**TOWN OF MOUNTAIN VILLAGE  
REGULAR DESIGN REVIEW BOARD MEETING  
THURSDAY MAY 3, 2018 10:00 AM  
2nd FLOOR CONFERENCE ROOM, MOUNTAIN VILLAGE TOWN HALL  
455 MOUNTAIN VILLAGE BLVD, MOUNTAIN VILLAGE, COLORADO  
AGENDA**

**TO:** Design Review Board  
**FROM:** Dave Bangert, Senior Planner/Town Forester  
**FOR:** DRB Meeting on May 3, 2018  
**DATE:** April 18, 2018  
**RE:** Consideration of a Design Review Application for a new retaining wall into the northern General Easement on Lot 657R, continued from the March 29, 2018 DRB meeting.

**TO:** Design Review Board  
**FROM:** Dave Bangert, Senior Planner  
**FOR:** Meeting of May 3, 2018  
**DATE:** April 25, 2018  
**RE:** Consideration of a Design Review application for a General Easement encroachment for a portion of a hot tub patio on Lot 149AR

**TO:** Design Review Board  
**FROM:** Dave Bangert, Senior Planner  
**FOR:** Meeting of May 3, 2018  
**DATE:** April 25, 2018  
**RE:** Final Design Review for a new single-family dwelling on Lot 432, 110 Highlands Way.

**1 Fireplace**  
1/4" = 1'-0"

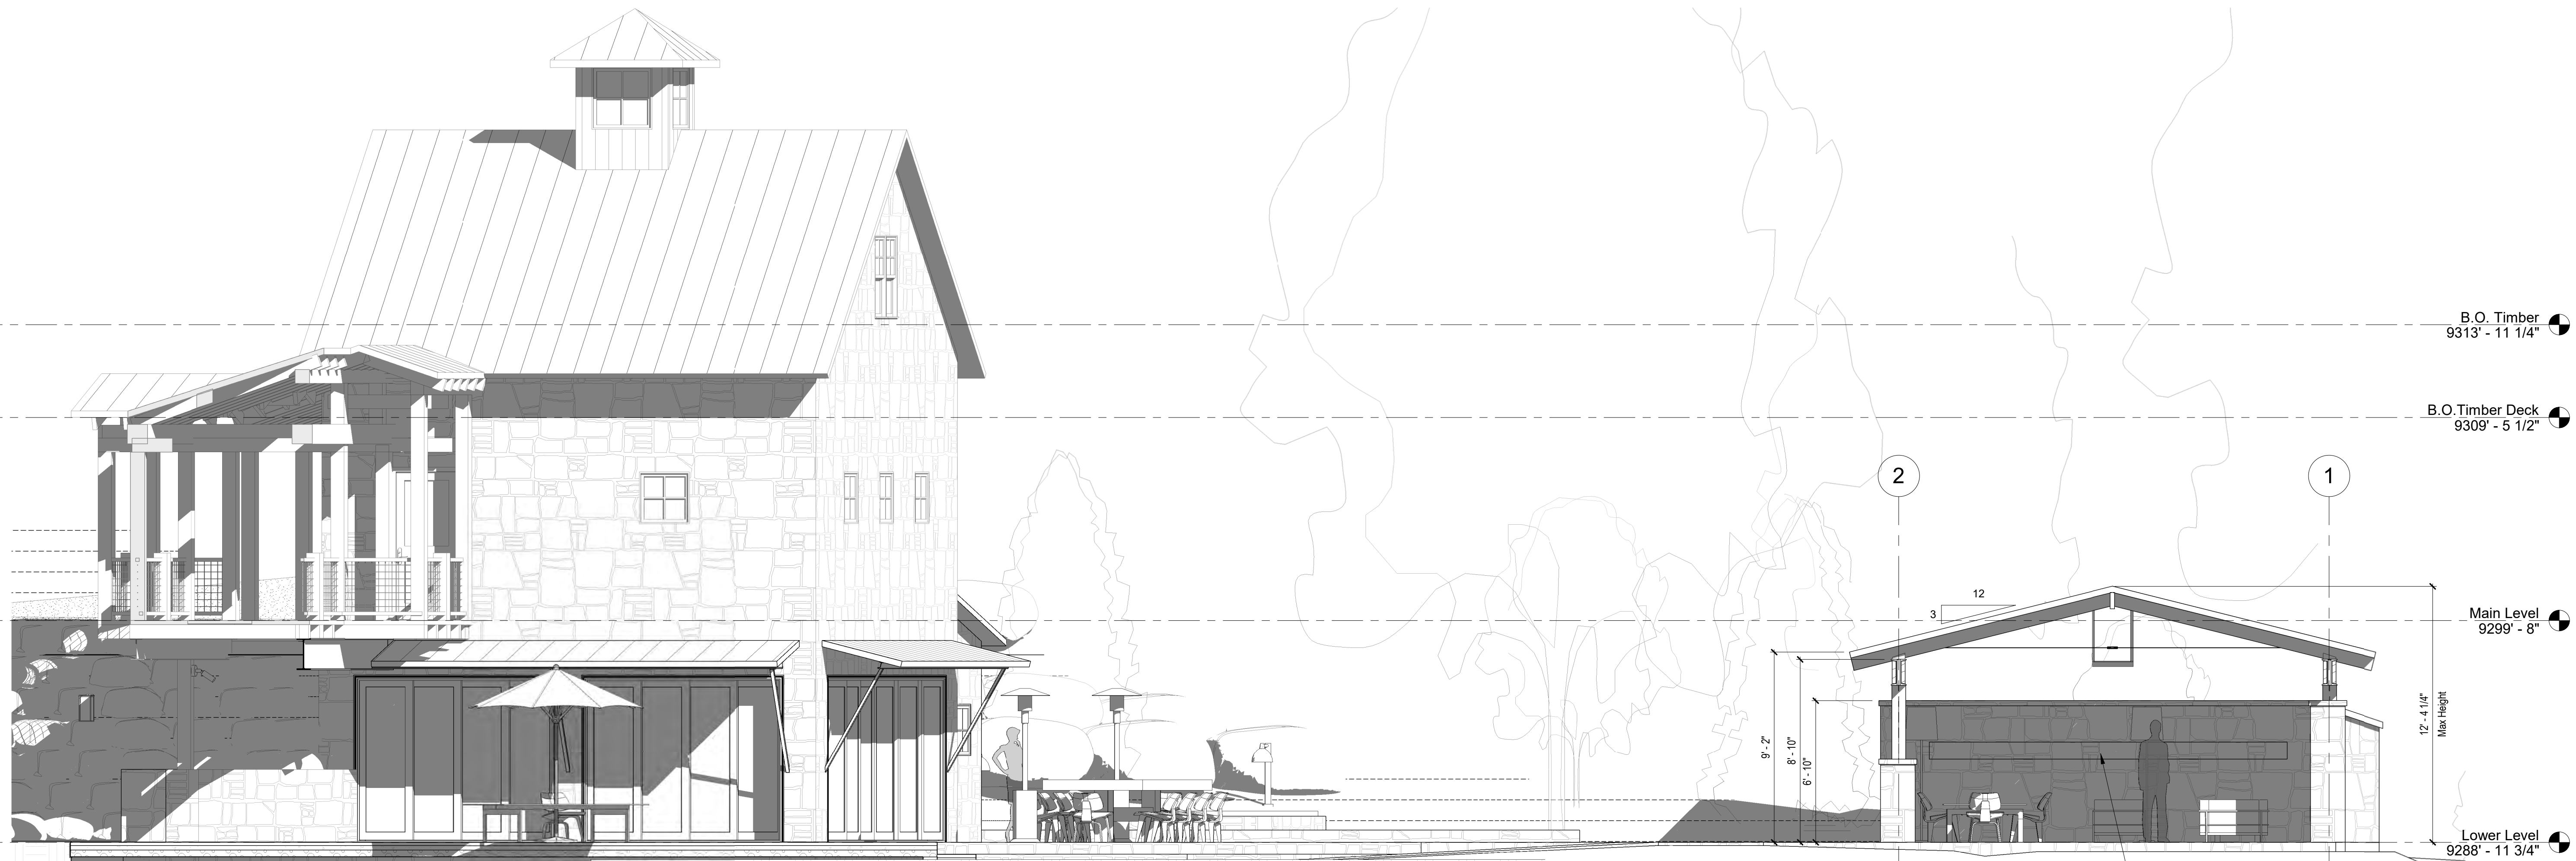
direction to reduce the size of the new outdoor fire pavilion to less than the 500-square foot maximum allowed. The new design has been reduced to 493 square feet. The Board also directed the applicant to reduce the amount of exterior lights. The original exterior lighting plan had a total of 50+ exterior fixtures. The updated exterior lighting plan has a total of 28 fixtures.

1. Outdoor heated patios have been updated with color coding per sheet A004.
2. Fire pavilion space has been redesigned to 493 SF with a new 3:12 roof at a total height of 12'-4.25"
3. Driveway lights have been reduced to [3] on the south edge per DRB conditions. These lights are B2 on the lighting plans.
4. Lighting in the fire pavilion has been adjusted. Please see AE design sheet L002.
5. All up lights near the ADU room have been removed.
6. Lights at hot tub have been adjusted for safety and code.
7. An optional umbrella light is shown with full cut-off per sheet L002.
8. Entertainment room is now labeled ADU per David Eckman.
